### REPORT SUMMARY MINOR VARIANCE APPLICATION FILE NUMBER A013/25

### MINOR VARIANCE APPLICATION FILE NUMBER A013/25

CITY WARD #:	4
APPLICANT:	Benjamin & Orit Smith
AGENT:	Contempo Studio
PROPERTY:	104 Sir Modesto Court, Maple
ZONING DESIGNATION:	See below.
VAUGHAN OFFICIAL PLAN	Vaughan Official Plan 2010 ('VOP 2010'): "Low Rise Residential"
(2010) DESIGNATION:	
RELATED DEVELOPMENT APPLICATIONS:	N/A
PURPOSE OF APPLICATION:	Relief from the Zoning By-law is being requested to permit the construction of a proposed two-storey dwelling, retaining wall, swimming pool, accessory structure (pool mechanical) and uncovered platform.

### 1 SITE PLAN 1" = 10'-0"

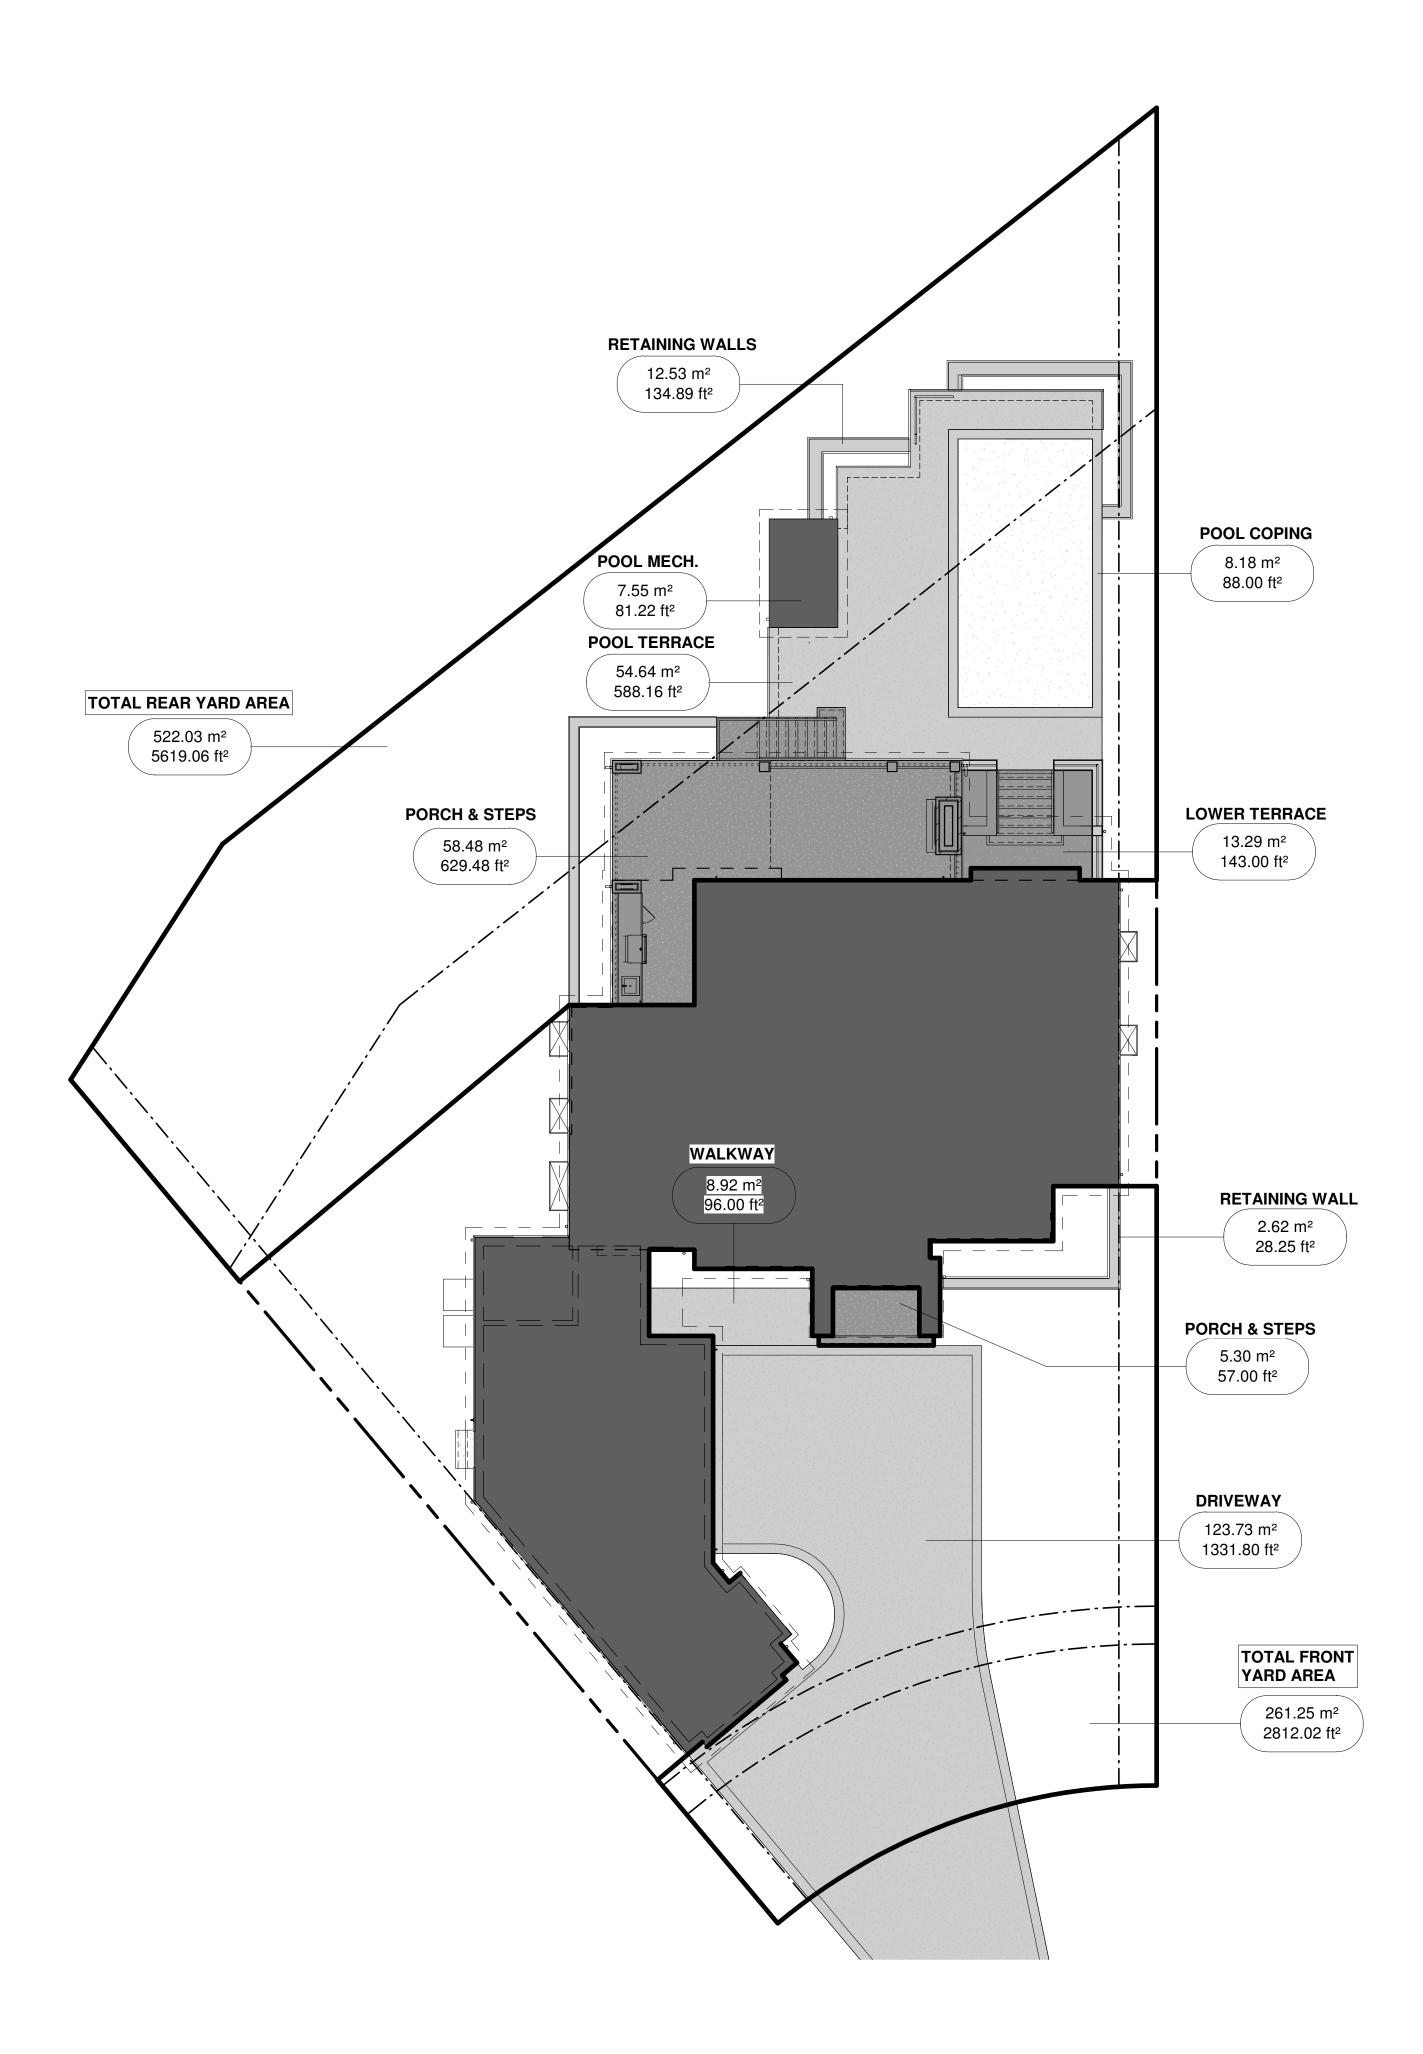
The Development and Parks Planning Department has no objections to Variance 1 to increase the maximum permitted driveway width from 9 m to 10.26 m. The configuration of the proposed driveway is designed to serve a three (3)-car garage with multiple entry points. The proposed driveway is 10.26 m at its widest point to facilitate vehicular access. The driveway width is approximately 7.27 m when measured at the front lot line, which is smaller than the maximum permitted driveway width. The remainder of the front yard has adequate space for landscaping opportunities, and the proposed driveway width is not anticipated to impact the streetscape.

The Development and Parks Planning Department has no objections to Variances 4, 5, and 6 to permit various setbacks to the raised terrace and the integrated swimming pool in the rear yard. The raised terrace is proposed to be located 2 m above the established grade. The raised terrace is surrounded by two (2) raised planters toward the rear lot line, which creates a step-down effect to mitigate massing impacts on the public open space abutting the rear of the property. The proposed setbacks of 2.22 m to the rear yard and 0.82 m to the west interior side yard are sufficient for access. The proposed swimming pool is in line with the raised terrace and is sufficiently setback from the west interior side lot line to accommodate access and maintenance.

$\rightarrow$		
VARIANCE #2 Window well with a depth of		_
Window well with a depth of 1.13m is setback from interior side lot line 0.62m	No. Issued for: Date 1.

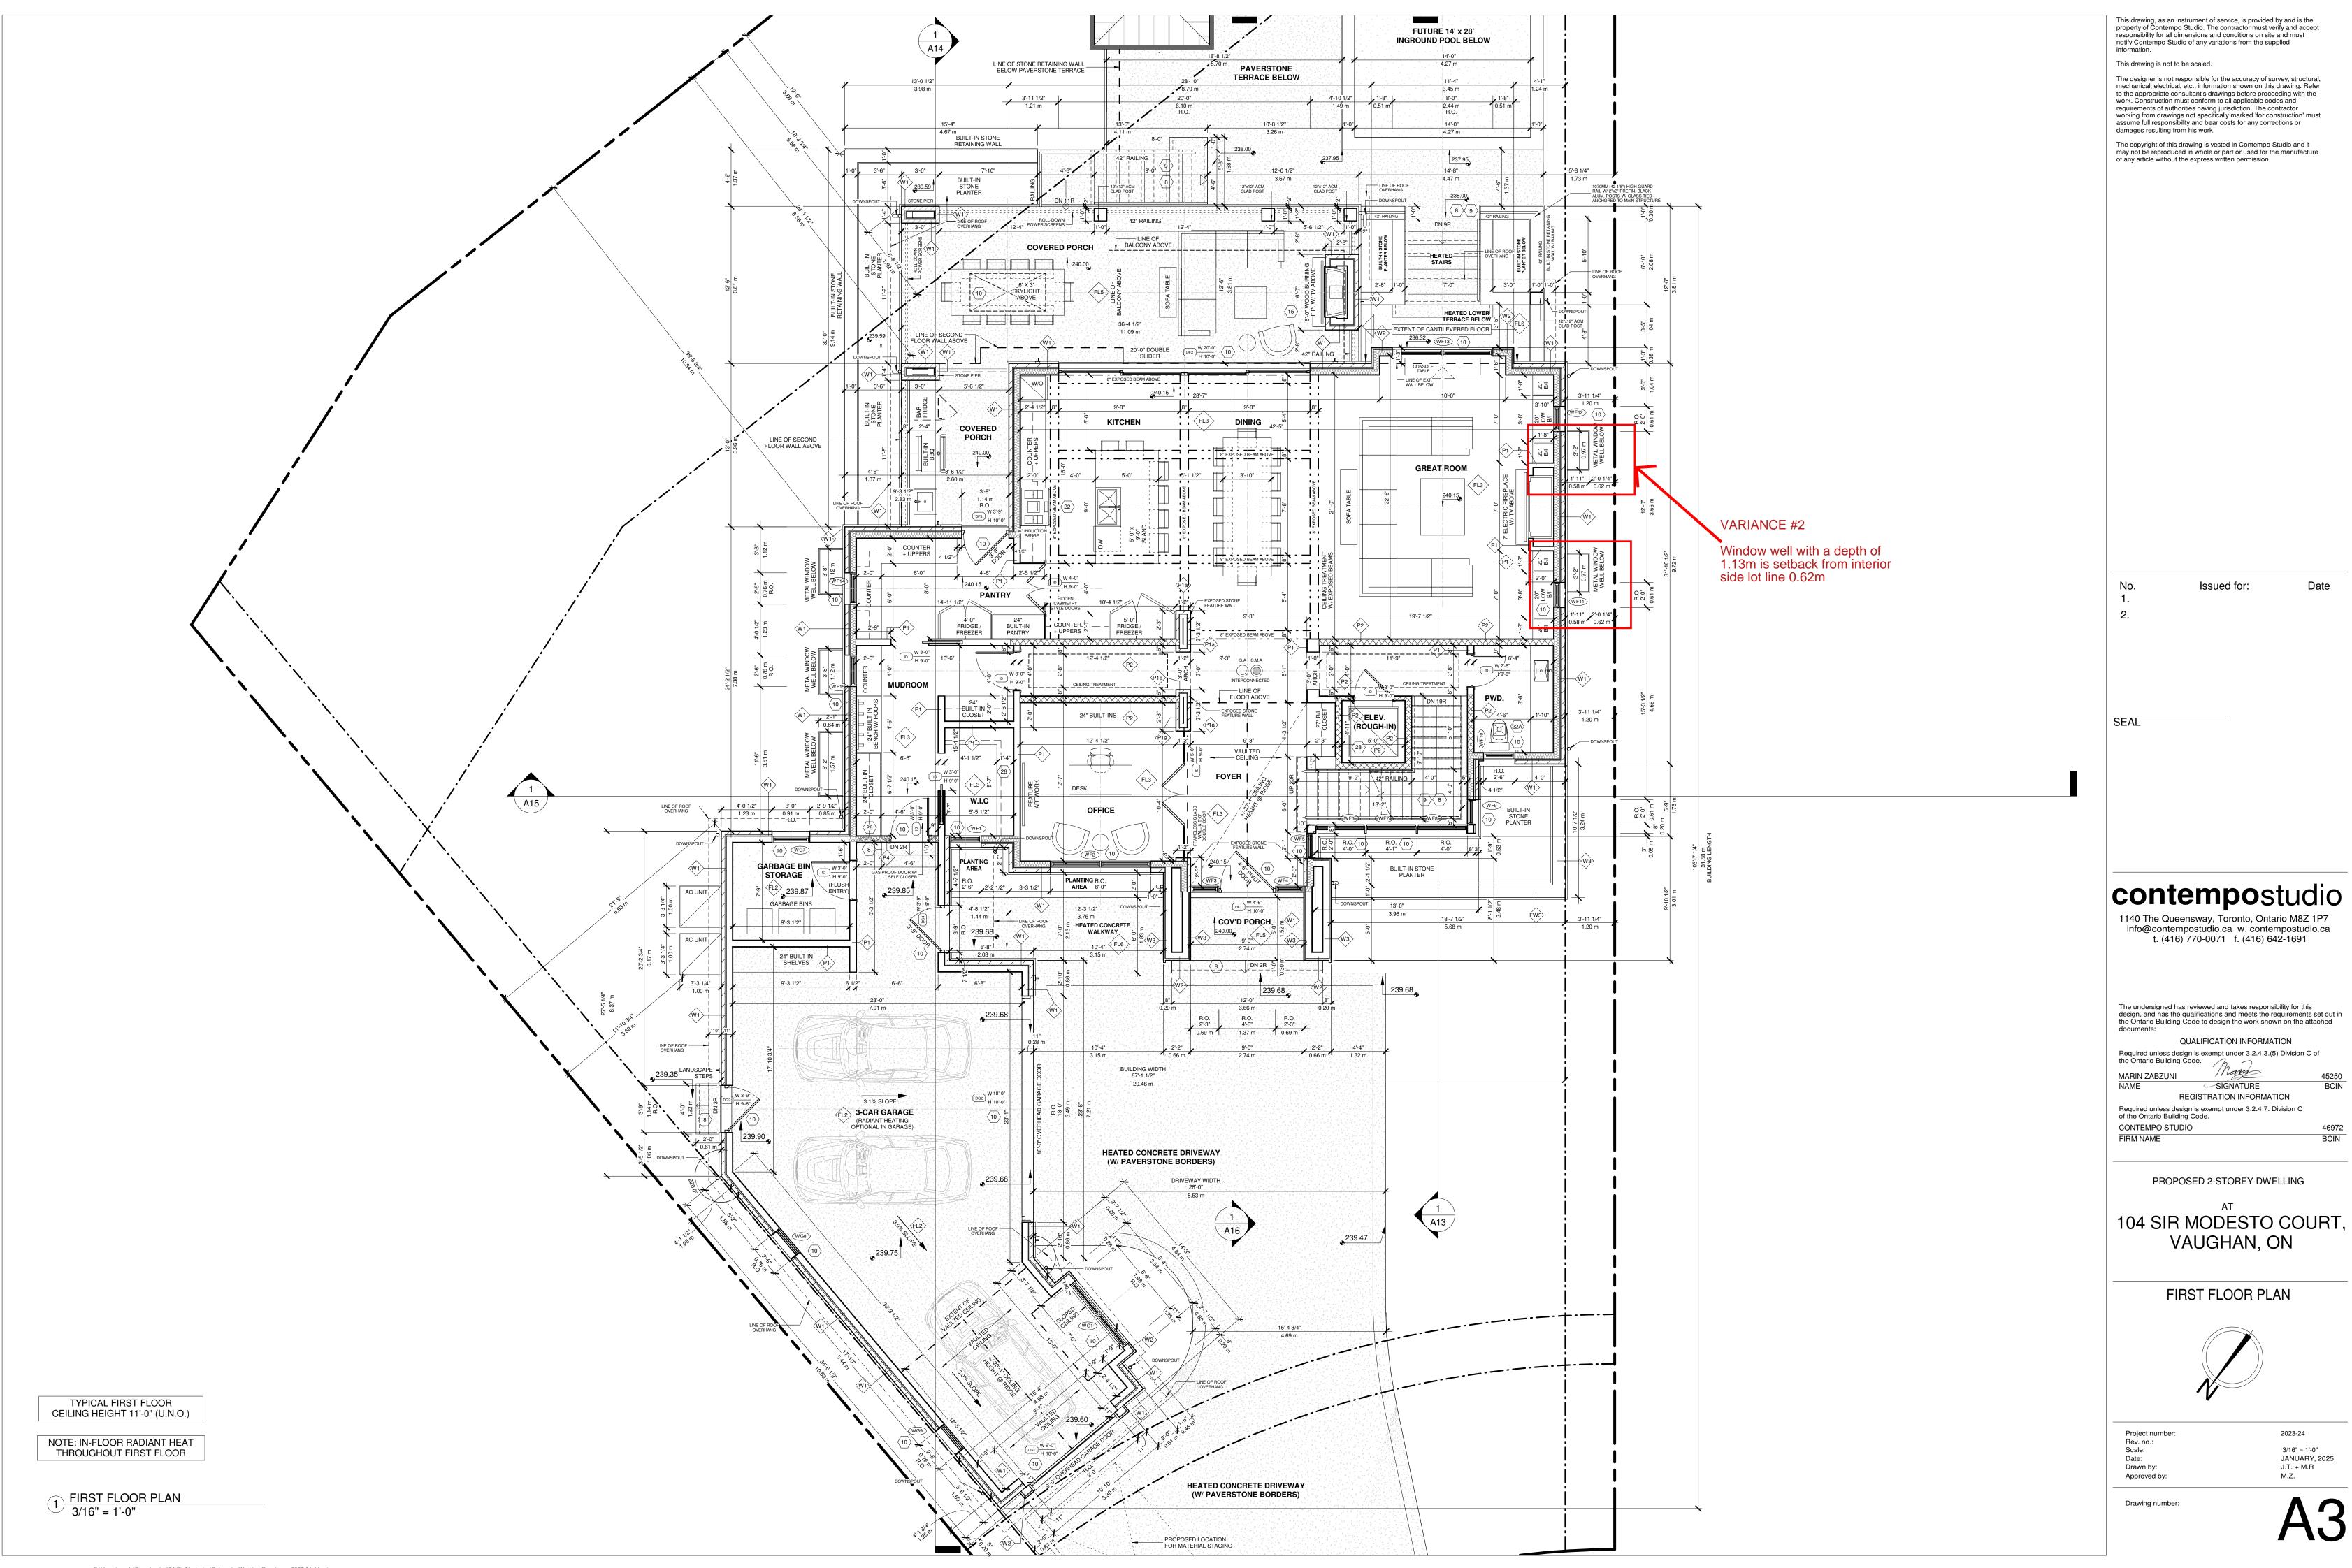
The Development and Parks Planning Department has no objections to Variance 2 to permit two window wells located within the west interior side yard with 0.62 m setbacks to the west lot line. The proposed window wells are located along the west wall of the proposed dwelling. The window wells are mostly located below grade, and will not create

### POOL MECH. RIGHT ELEVATION

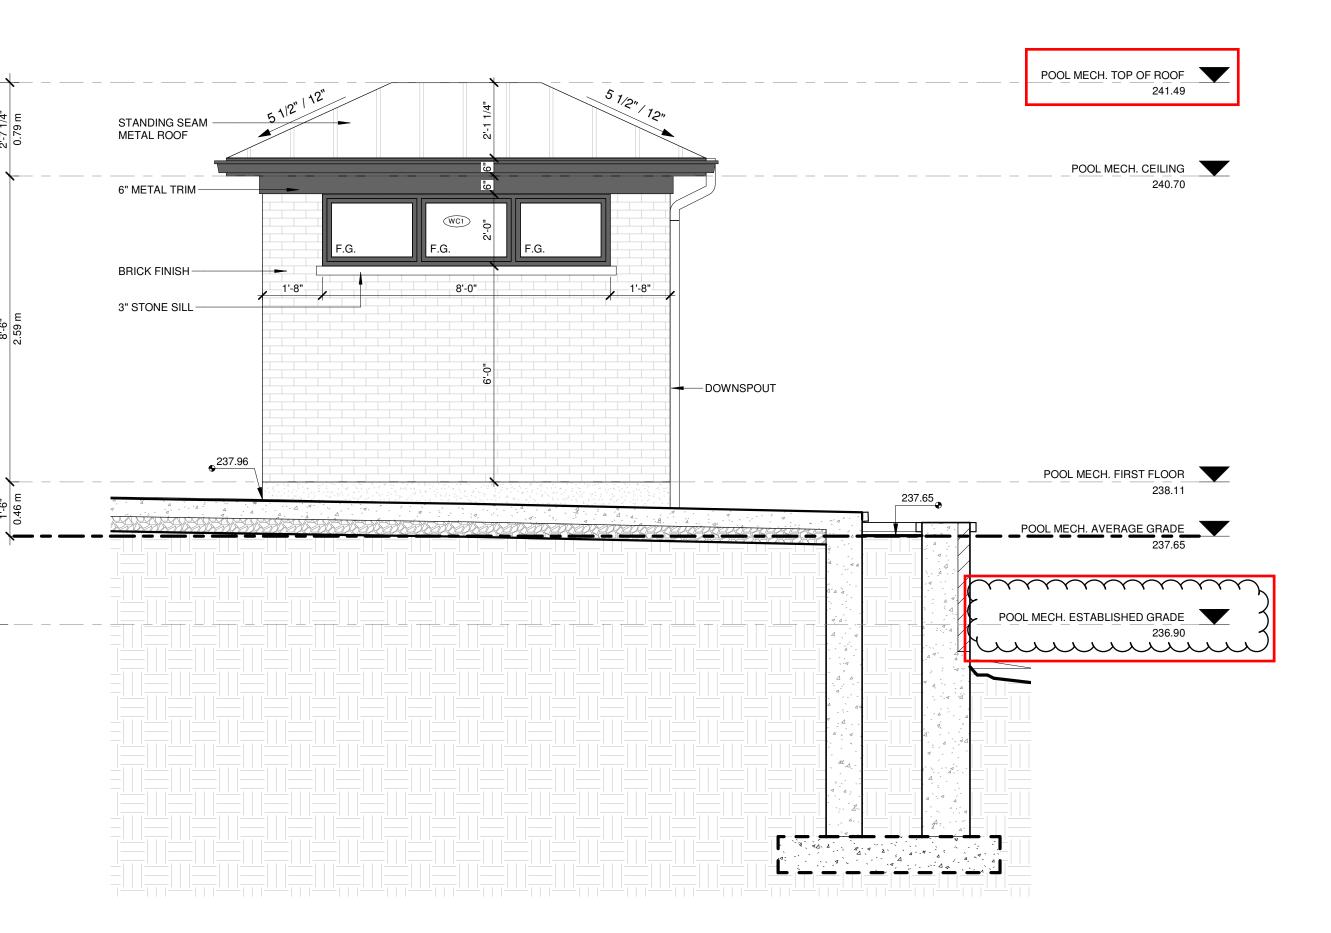
The Development and Parks Planning Department has no objections to Variance 3 to permit a 4.59 m tall pool equipment shed in the rear yard. The shed abuts the raised terrace and the height is measured from established grade. The shed has a floor area of less than 10 m<sup>2</sup>, complies with setback provisions, and is not anticipated to incur massing concerns on the neighbouring residential properties.
